Request	-	Major Site Plan Review for New Parking Lot
Location	-	3301 Central Avenue
Applicant	-	Lawrence Dziurdzik Costco Wholesale Corporation 1955 Raymond Drive, Suite 119 Northbrook, IL 60062
Property Owner	-	Westgate Village Retail, LLC 30 N. Lasalle Street, Suite 2120 Chicago, IL 60602
Architect	-	MG2 1101 Second Avenue, Suite 100 Seattle, WA 98101
Engineer	-	Civil & Environmental Consultants, Inc. 10300 Alliance Road, Suite 300 Cincinnati, OH 45242

The staff recommends that the Toledo City Plan Commission approve SPR25-0029, a Major Site Plan Review for a New Parking Lot at 3301 Central Avenue, for the following three (3) reasons:

MAJOR SITE PLAN REVIEW
TOLEDO CITY PLAN COMMISSION
REF: SPR25-0029
DATE: August 14, 2025
TIME: 2:00 P.M.

OVERALL SITE PLAN

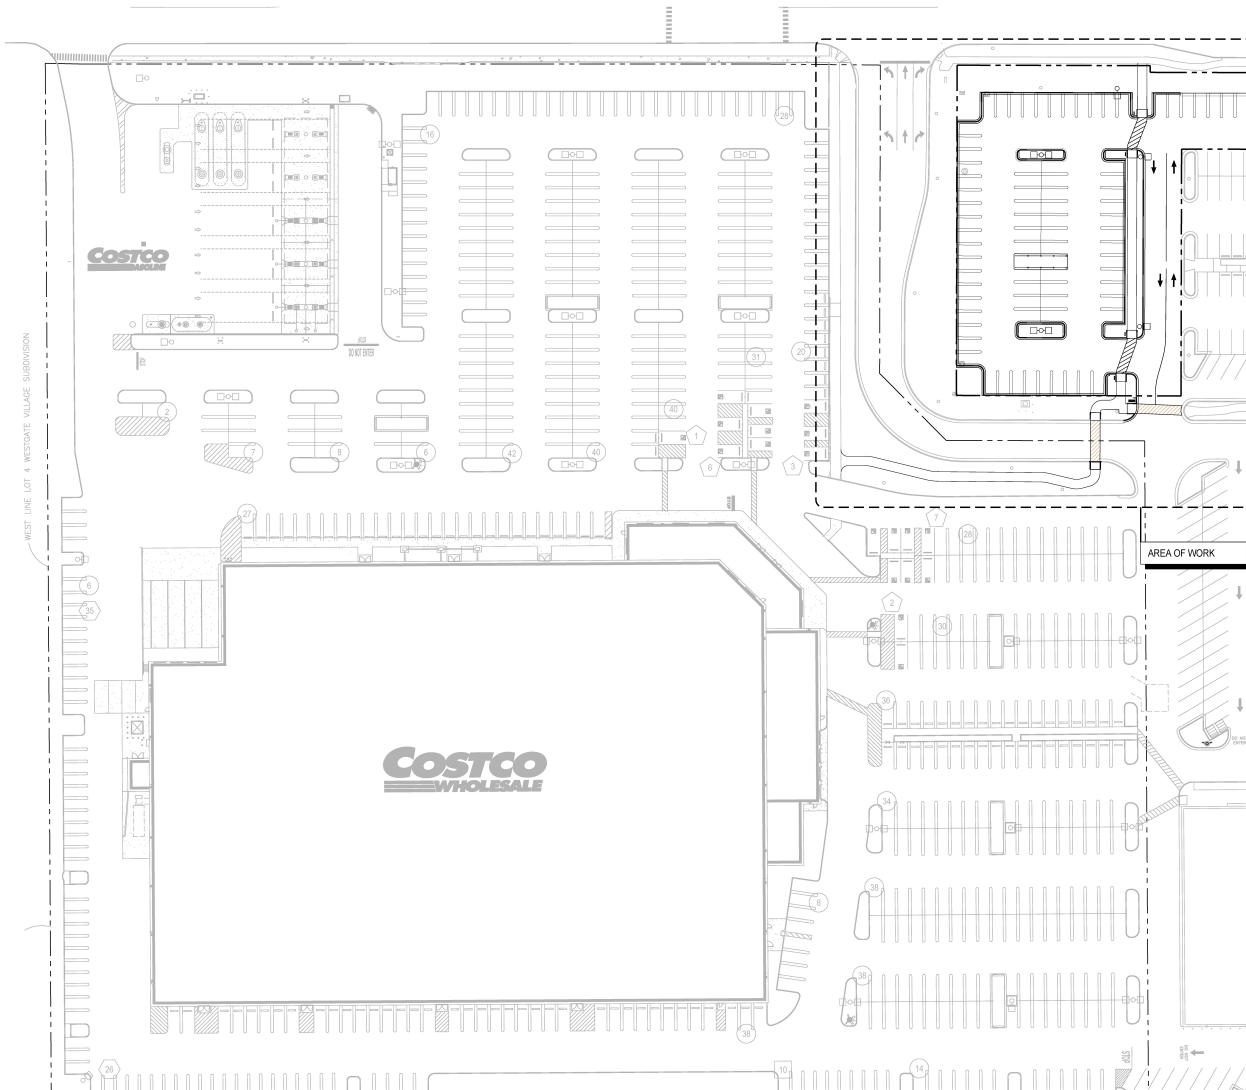
2. The cross walk crossing main drive lanes needs to be moved East to other side of the stop line. Consideration should be given to making that a raised crosswalk for pedestrian safety.

16. A raised crosswalk shall be installed across the drive labeled "Markway Road" – otherwise known as the site's main drive access to Central Avenue – between the proposed additional parking the existing Costco store. **Not acceptable as depicted on site plan. Crosswalk details shall be submitted to the Plan Director and Division of Traffic Management for review and approval.**
17. An additional crosswalk shall be installed across the north-south drive aisle between the proposed additional parking and the existing pedestrian walkway leading to the site. **Not acceptable as depicted on site plan. A revised site plan shall be submitted to the Plan Director depicting this additional crosswalk.**

18. A minimum of sixteen (16) bicycle parking spaces shall be installed on the site. Bicycle parking spaces may be located on the additional parking property, the existing Costco property, or both. **Not acceptable as depicted on site plan. A revised site plan shall be submitted to the Plan Director depicting a minimum of sixteen (16) bicycle parking spaces.**
